March 7, 2025

PROJECT NAME: CALESA TOWNSHIP - CHESTNUT GROVE

PROJECT NUMBER: 2025010020

APPLICATION: IMPROVEMENT PLAN #32357

SHT. 01.01

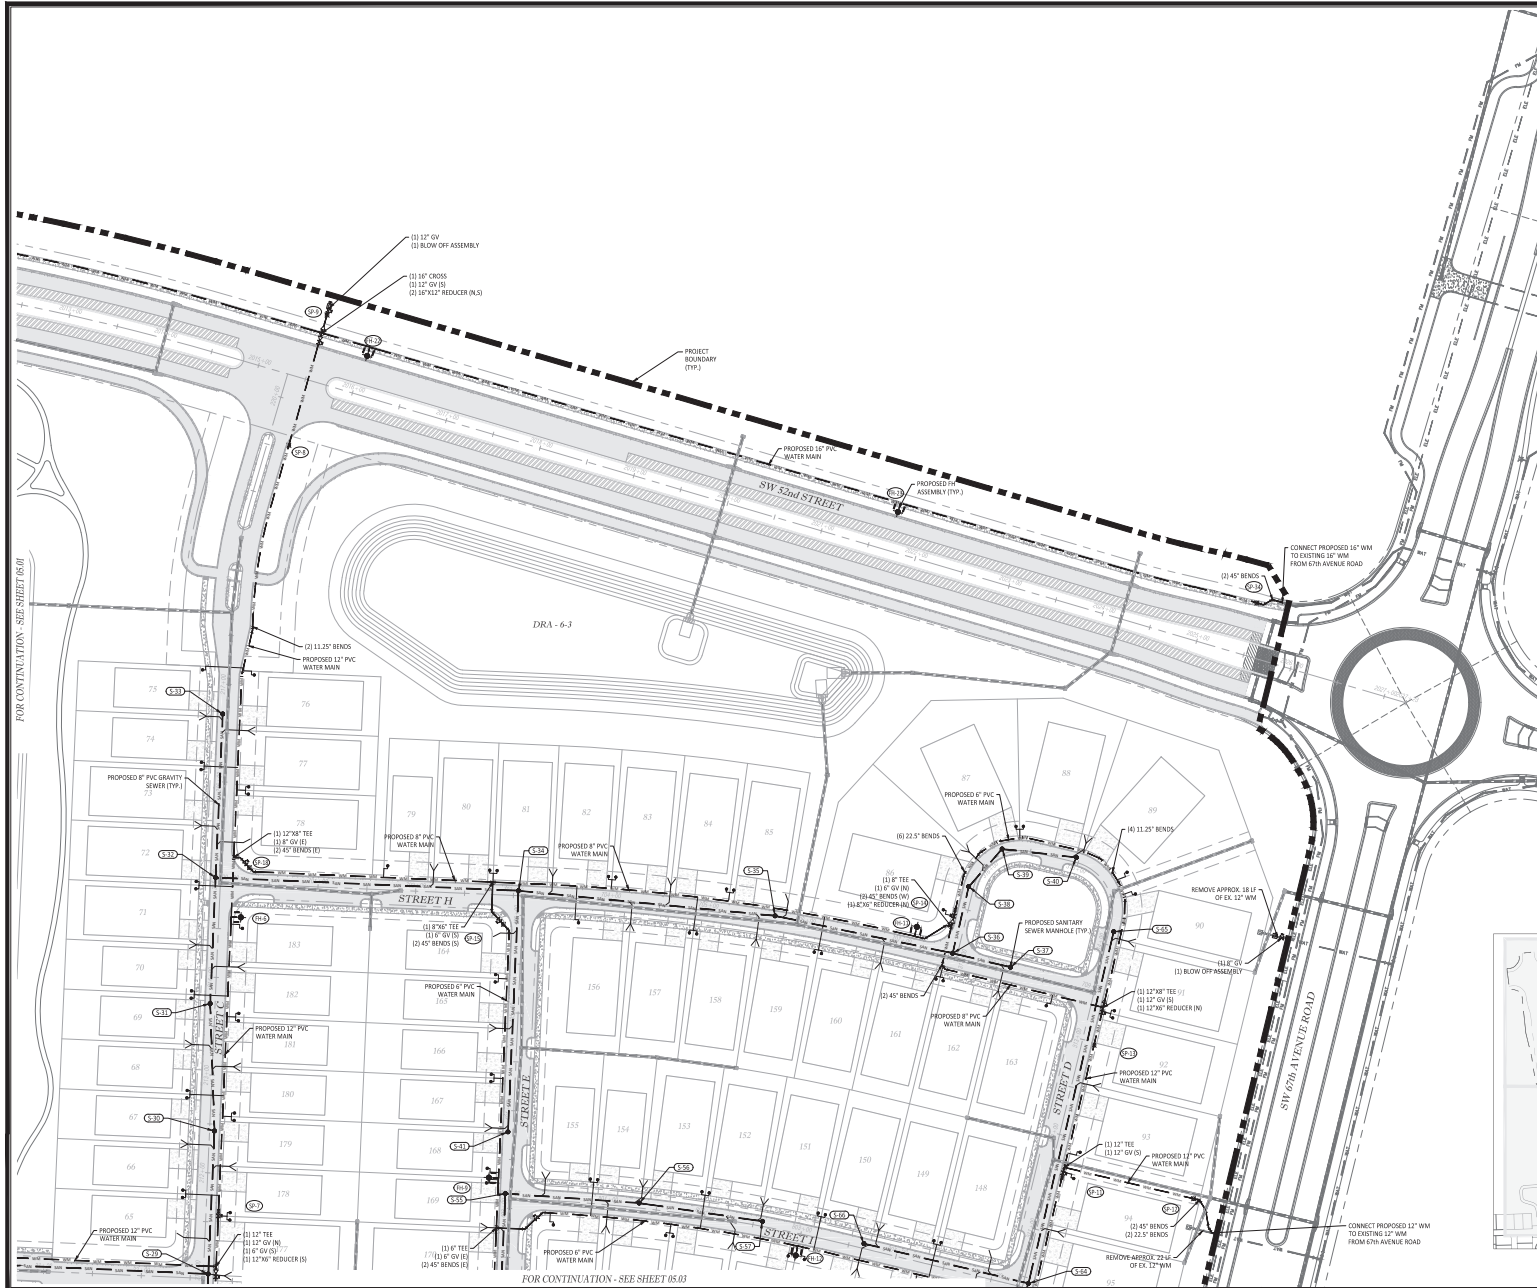
- 5 DEPARTMENT: ENGDRN - STORMWATER REVIEW
REVIEW ITEM: Additional Stormwater comments
STATUS OF REVIEW: INFO
REMARKS: (1) Cameron's last name is misspelled on the cover sheet of the plan set. (2) If you have questions or would like to discuss the stormwater review comments, please contact Kevin Vickers, PE at 352-671-8695 or kevin.vickers@marionfl.org.

SHT. 06.02

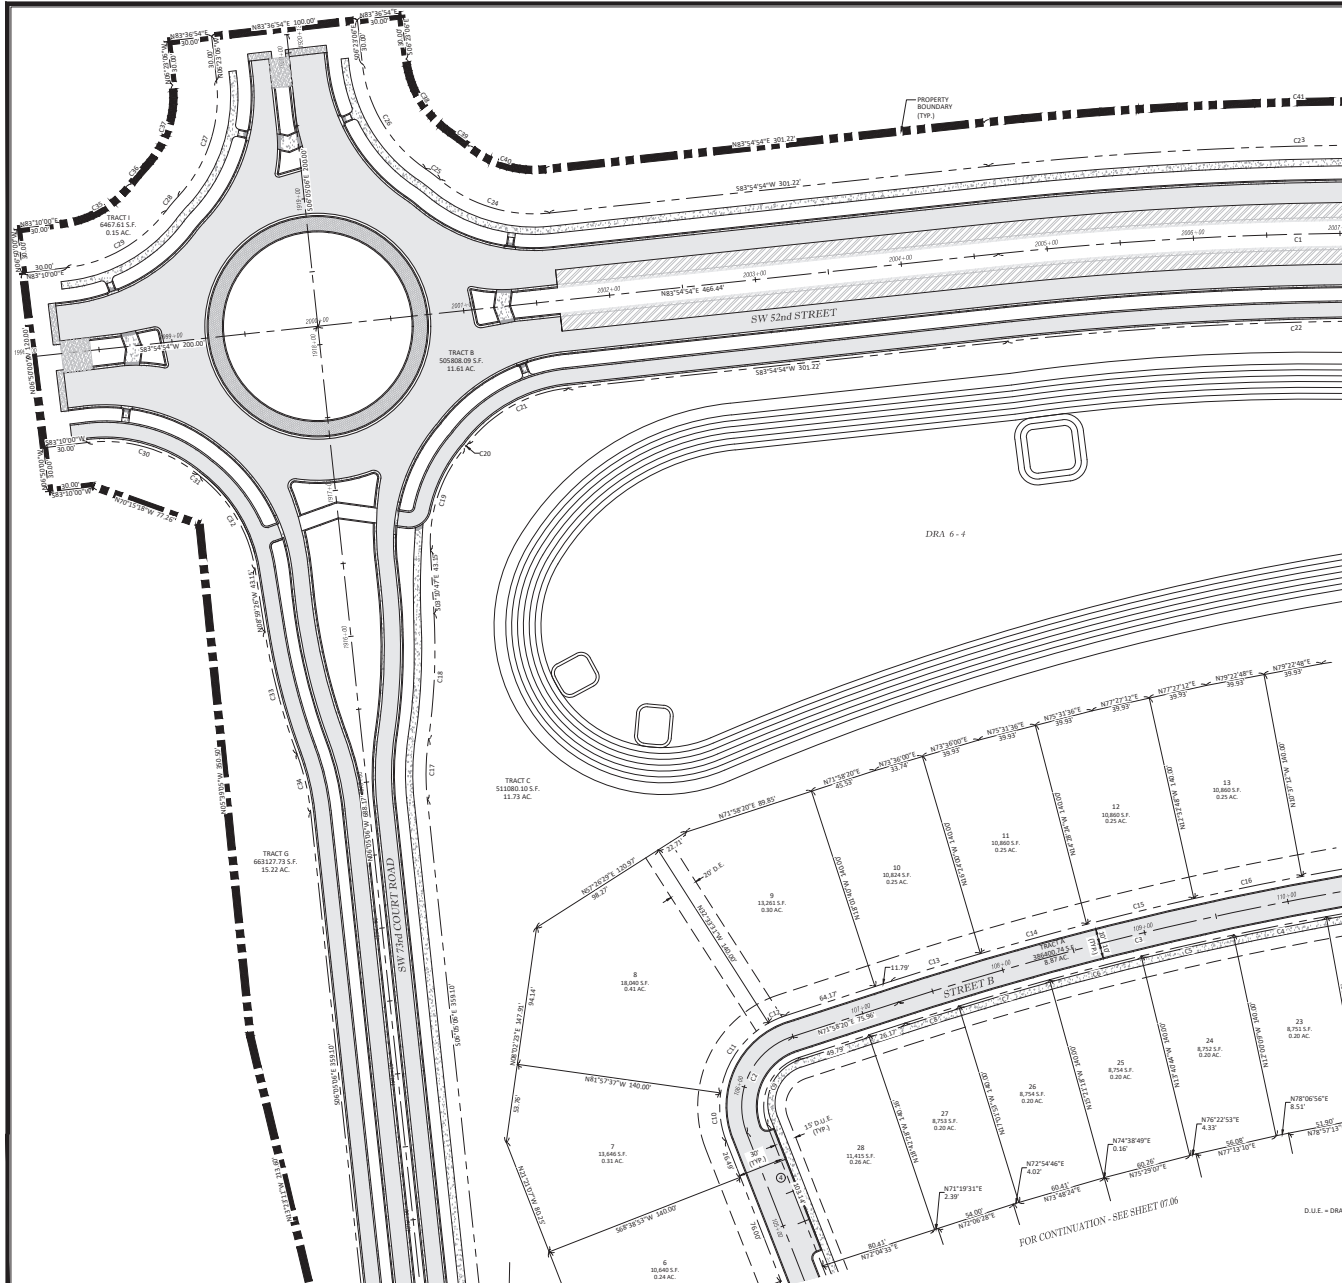
- 21 DEPARTMENT: ENGTRF - TRAFFIC REVIEW
REVIEW ITEM: 6.12.3 - Typical sections
STATUS OF REVIEW: NO
REMARKS: 1/23/25 - None of the typical sections on sheet 06.02 are compliant to Code or match those shown in the approved PUD. The alley section shown is the same as approved for Perlino Grove which was conditional upon an update to the Master Plan. A waiver and / or master plan update is required to enable approval of typical sections shown on sheet 06.02.

SHT. 07.01

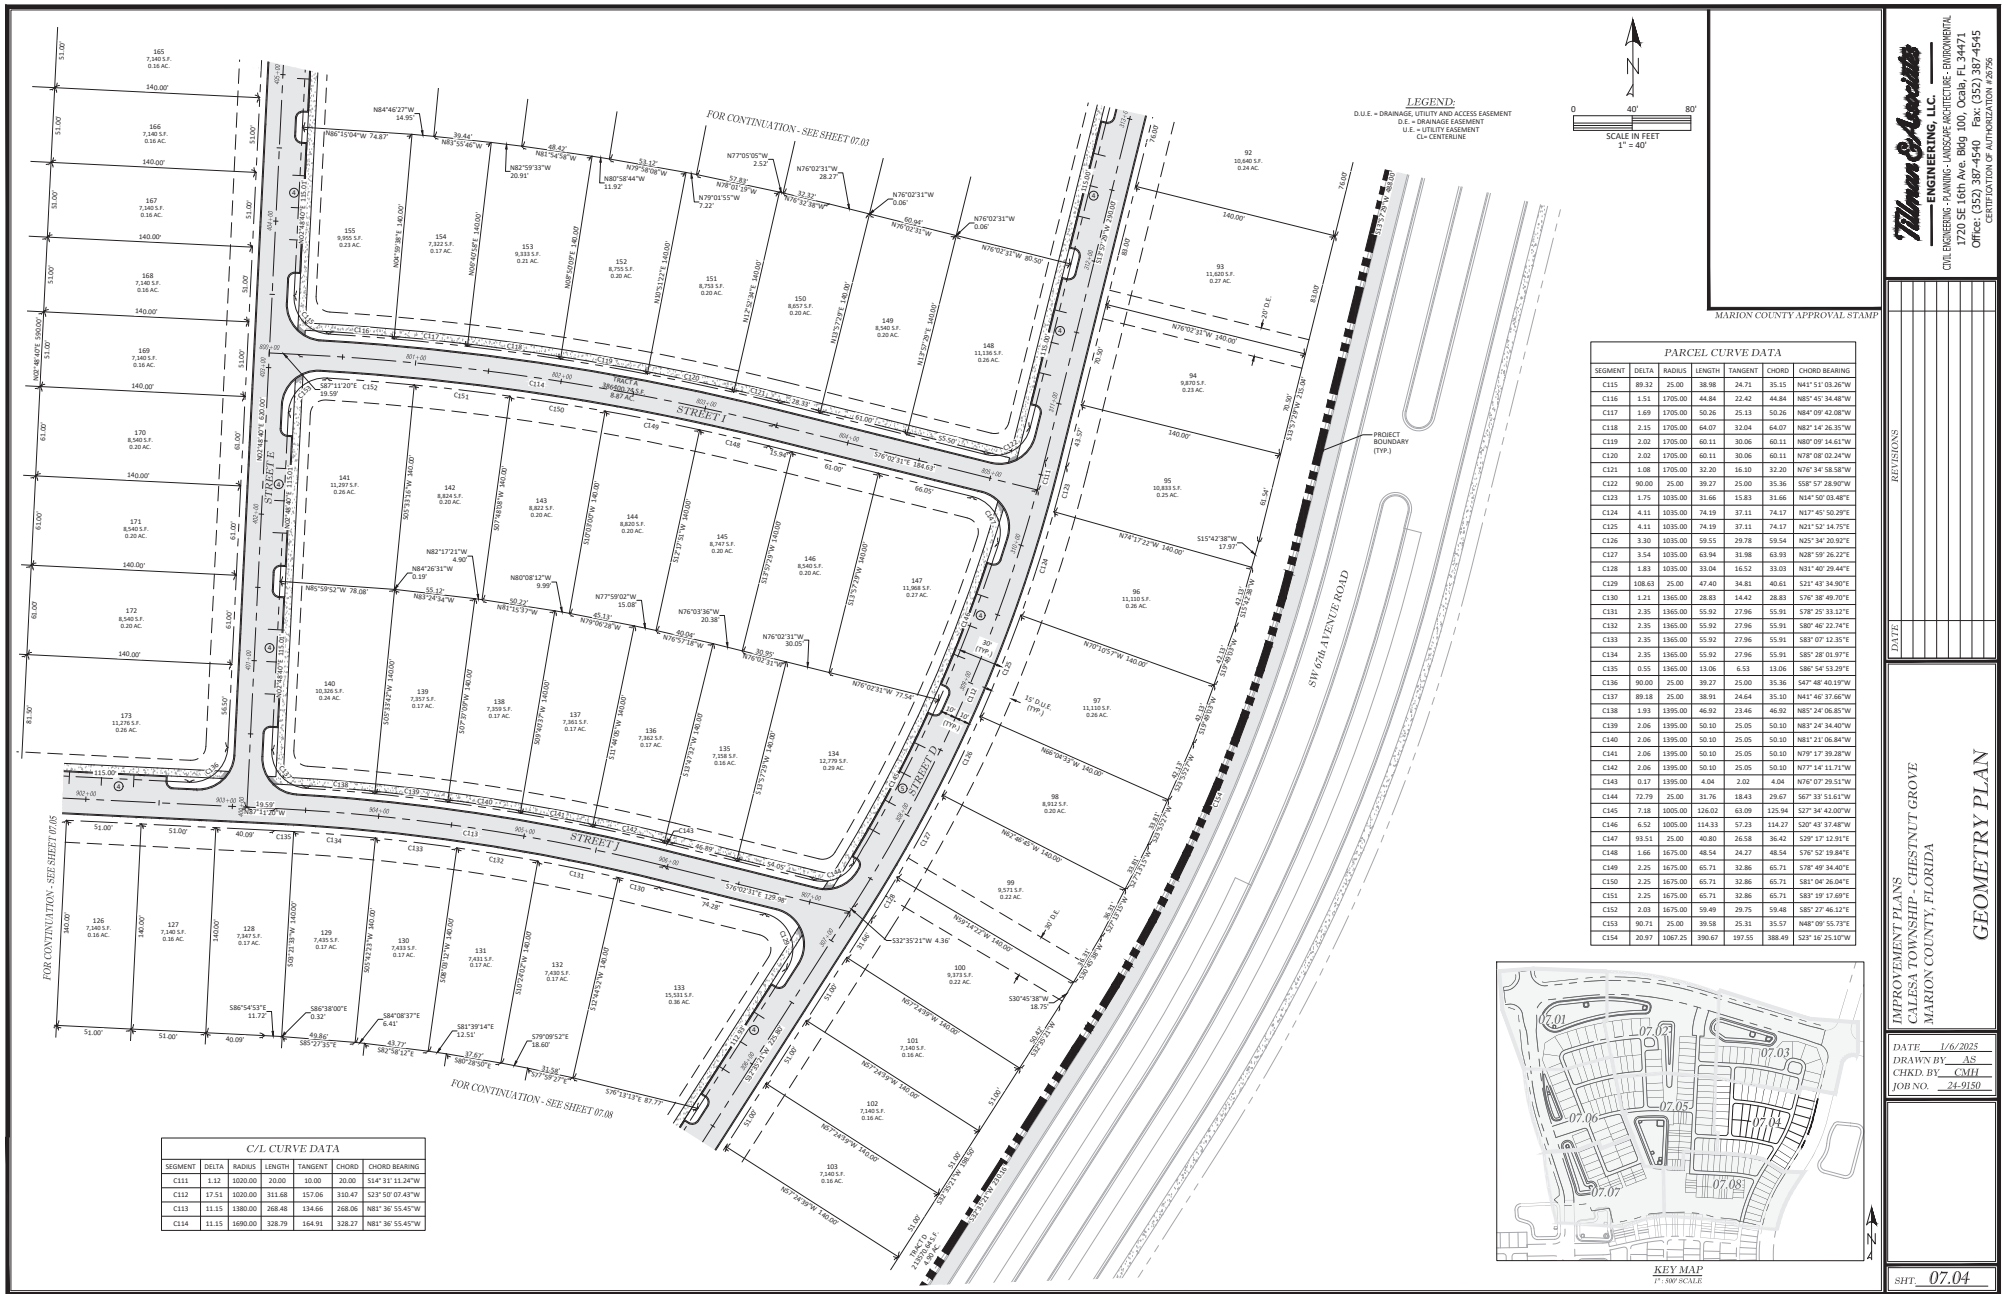
- 17 DEPARTMENT: ENGTRF - TRAFFIC REVIEW
REVIEW ITEM: 6.2.1.E - Drawing legend
STATUS OF REVIEW: NO
REMARKS: 1/23/25 - Sheet 07.01 (at a minimum) should include a legend that establishes symbology used for geometry plan sheets - similar to what is being required for preliminary plat.

SHT. 07.05

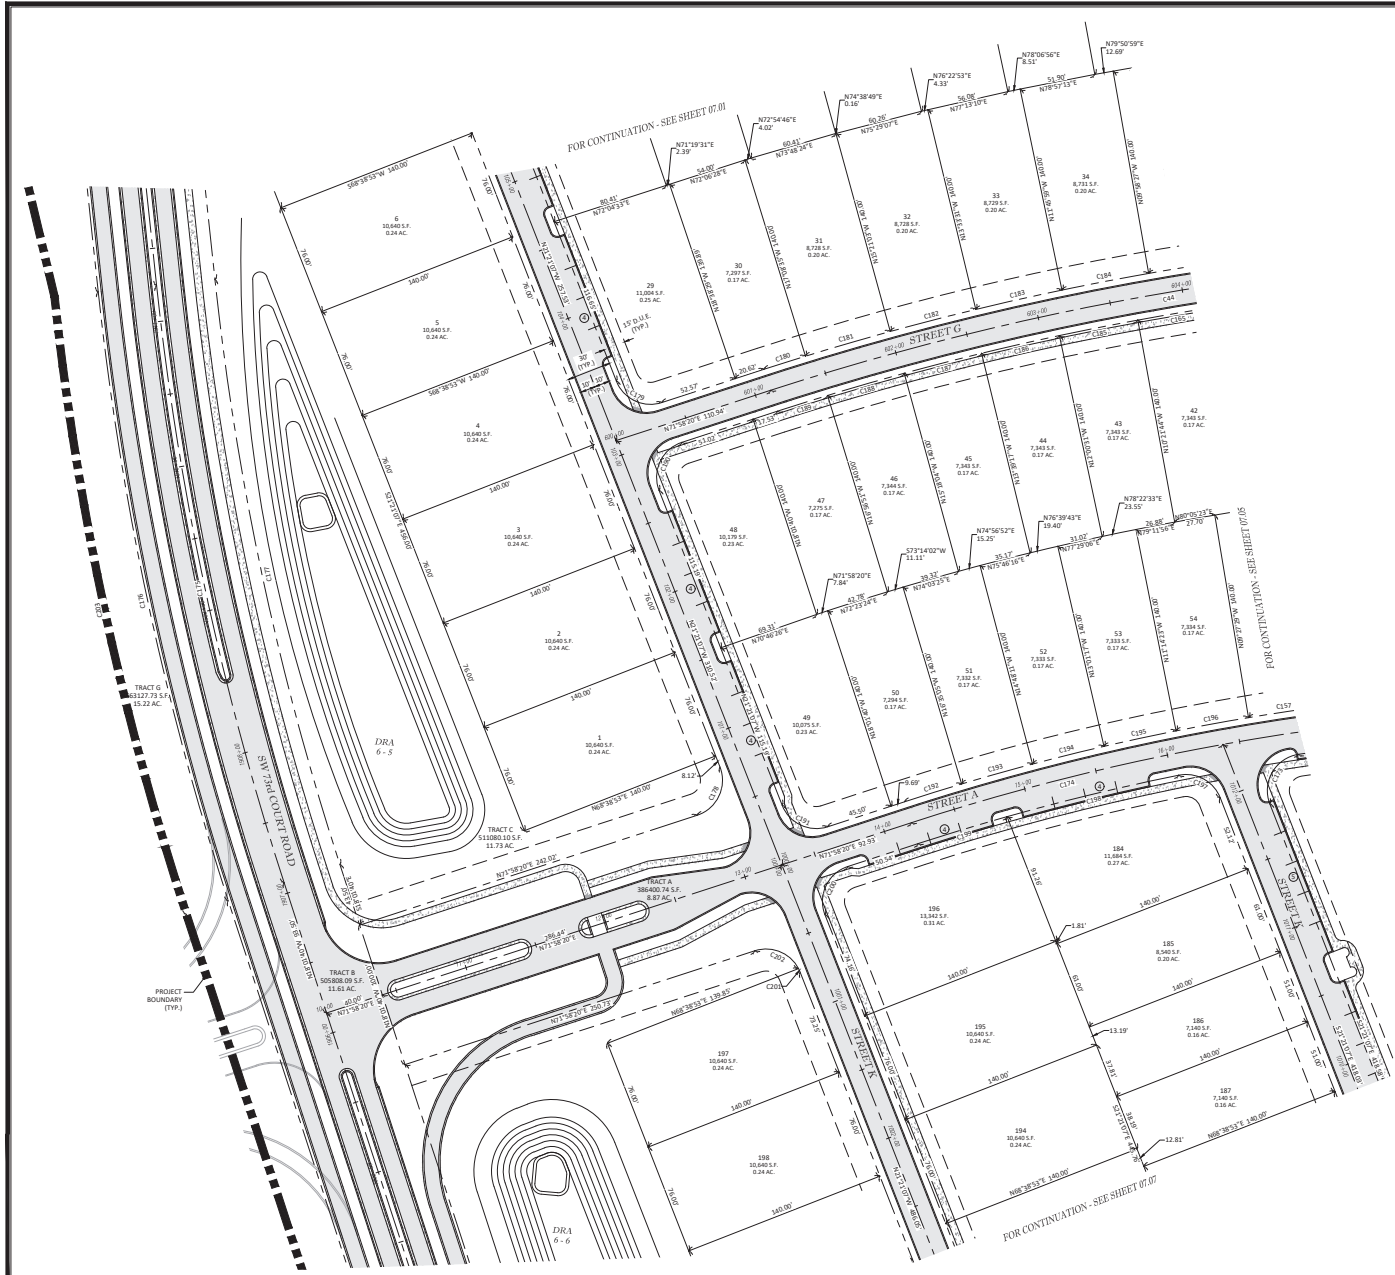
On page 7.05 the roadway Street M and N are under 20' in width.

SHT. 07.07

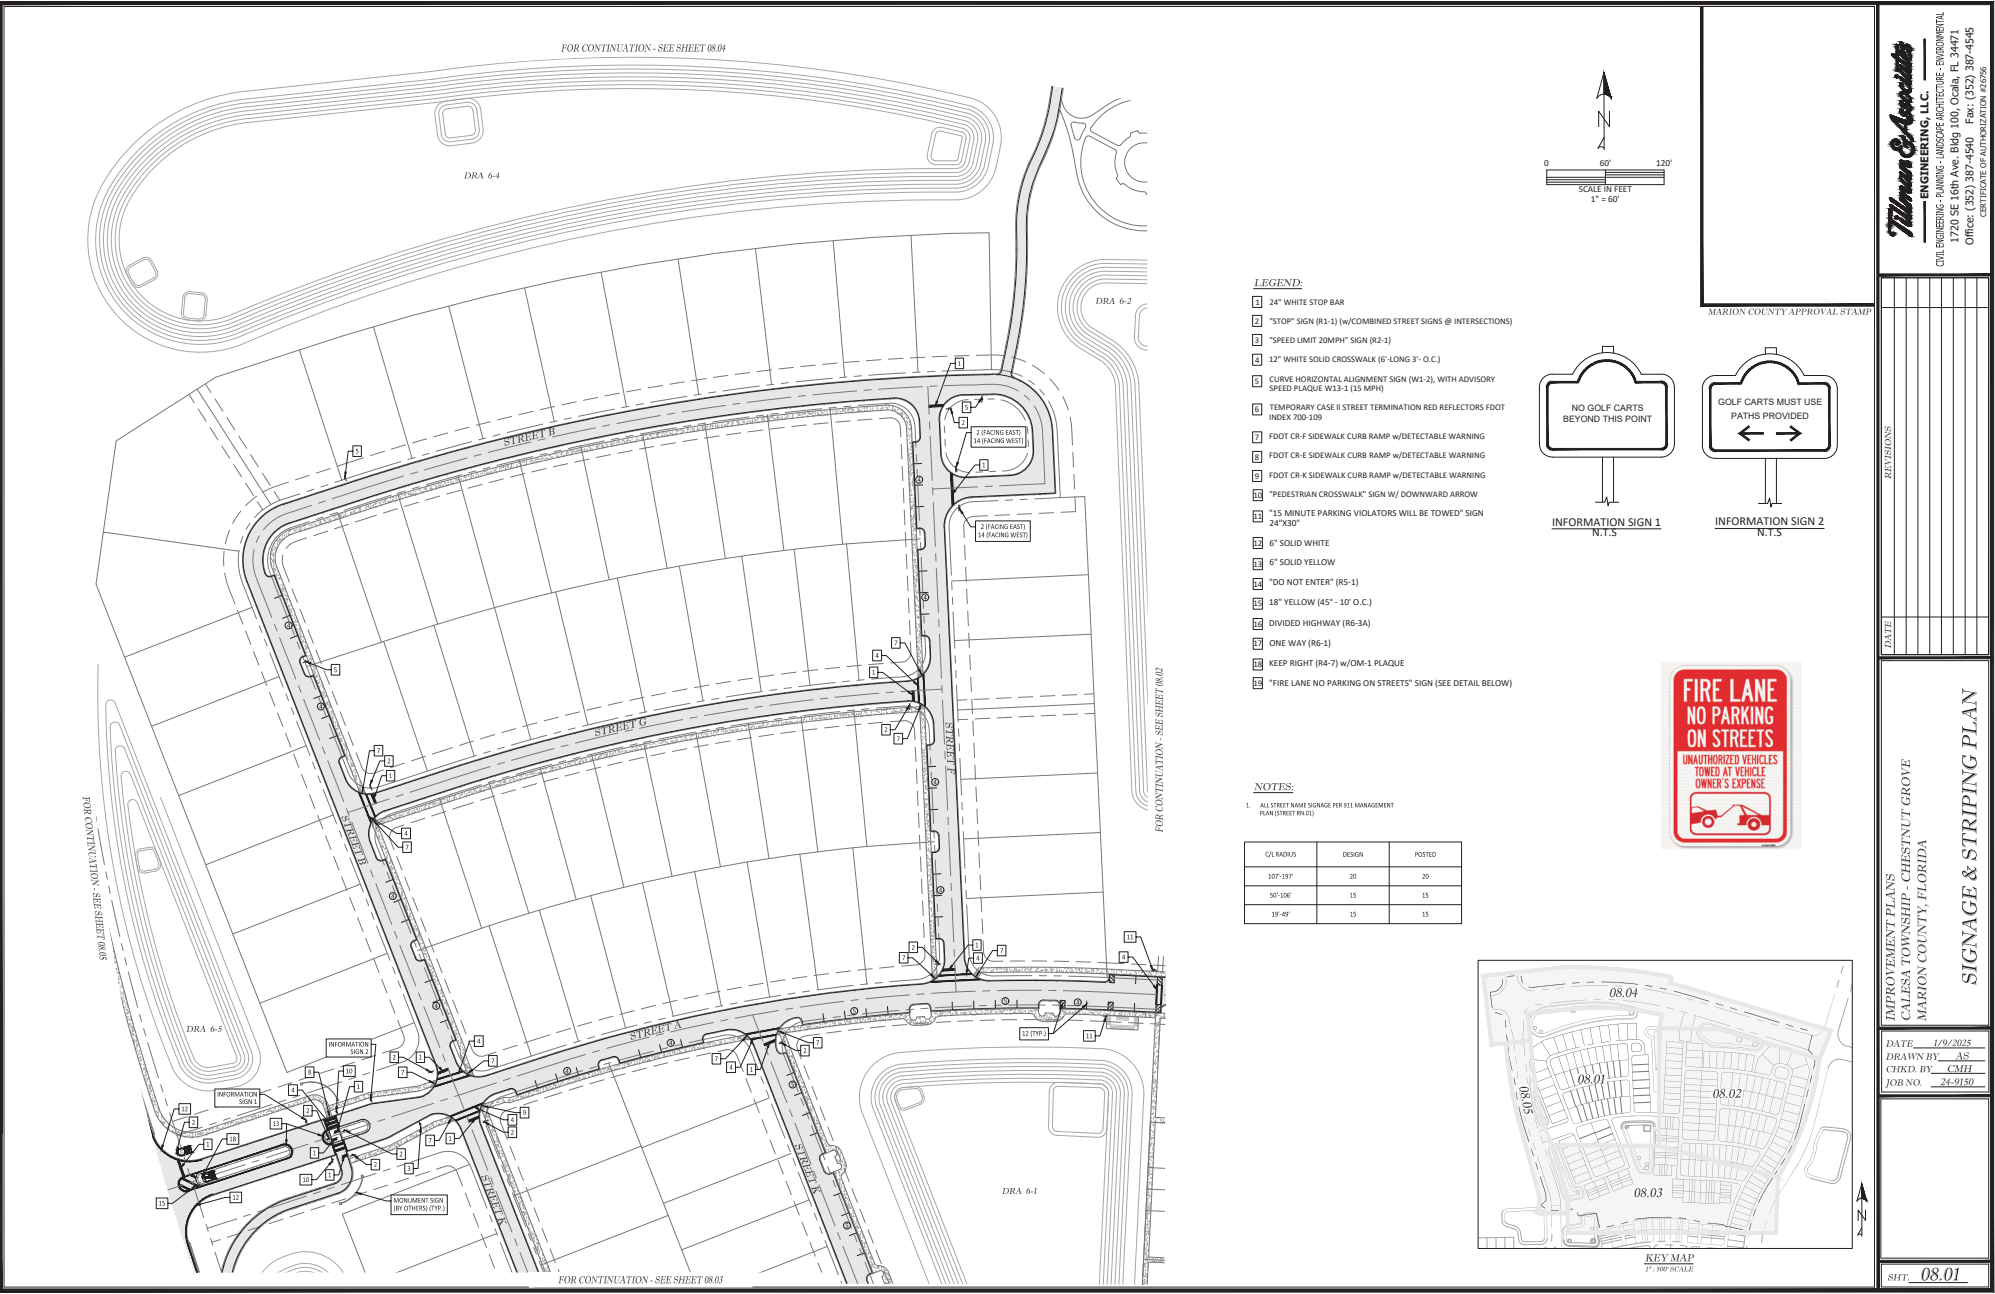
On page 7.07 the roadway Street O is under 20' in width.
